**SUSQUEHANNA STEAM ELECTRIC STATION
REQUEST FOR ADDITIONAL INFORMATION FOR THE
REVIEW OF THE SUSQUEHANNA STEAM ELECTRIC STATION
UNITS 1 AND 2, LICENSE RENEWAL APPLICATION (LRA)
SECTION 2.5
PLA-6413**

**Docket Nos. 50-387
and 50-388**

**Enclosure to PLA-6413
PPL Response to NRC's
Request for Additional Information (RAI)**

Attachment to PLA-6413
SBO Scope Addition
Revised LRA Sections 2.1, 2.2, 2.4, 2.5, 3.5, 3.6

Figure 2.5-1
Graphical Representation of the SSES SBO License Renewal Boundary

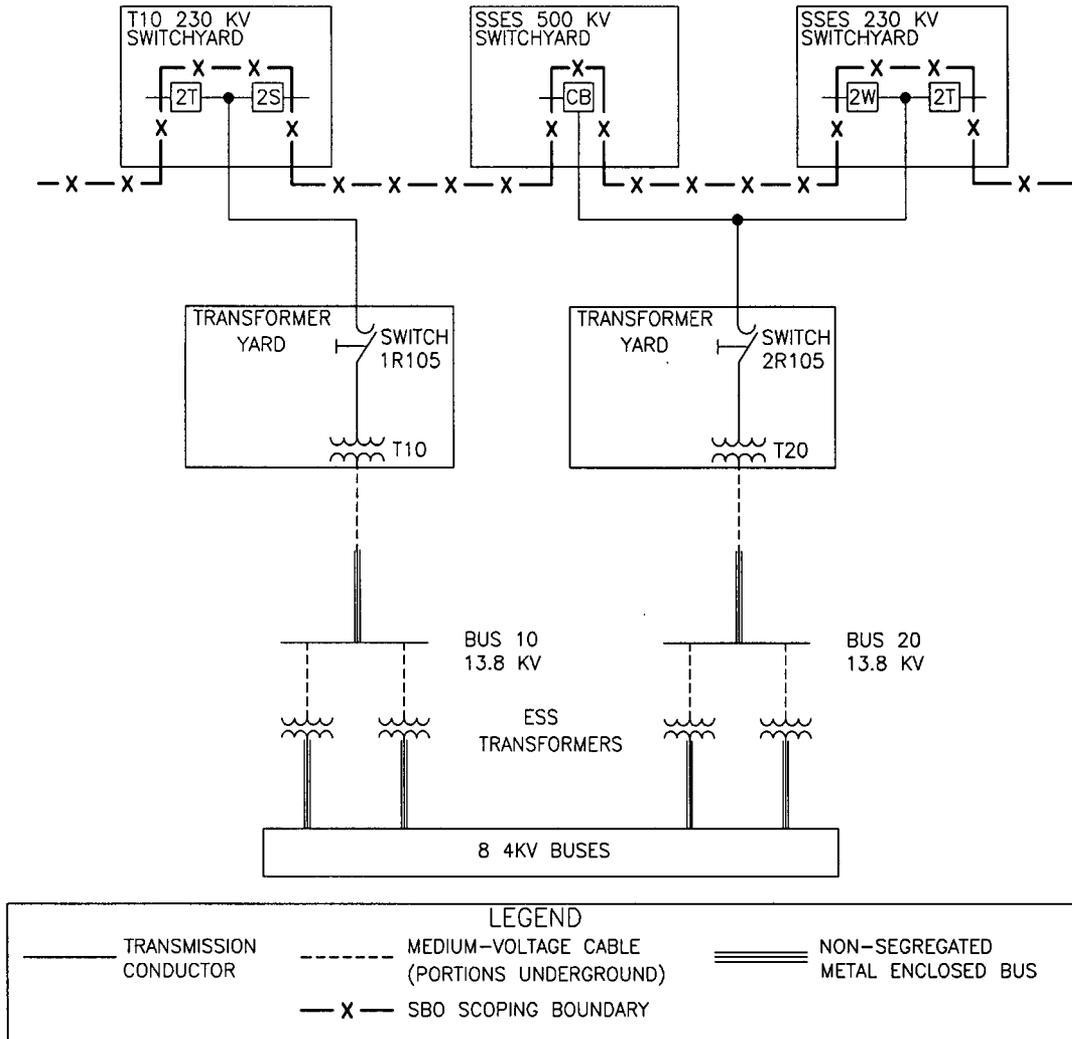
- The following figure under Section 2.5.6.2 (on LRA page 2.5-10) is replaced. The text associated with Figure 2.5-1 (on LRA page 2.5-10) is revised by addition (***bold italics***) and deletion (~~strikethrough~~).

As is shown ***at the top of this figure***, ***the SBO LR scoping boundary is at circuit breakers located in the three switchyards.*** ~~connection to the grid is made in the transformer yards at switches 1R105 and 2R105. All of the 230 kV components in the plant portion of the offsite power system are listed in the plant's equipment database as part of the 13.8 kV electrical system.~~
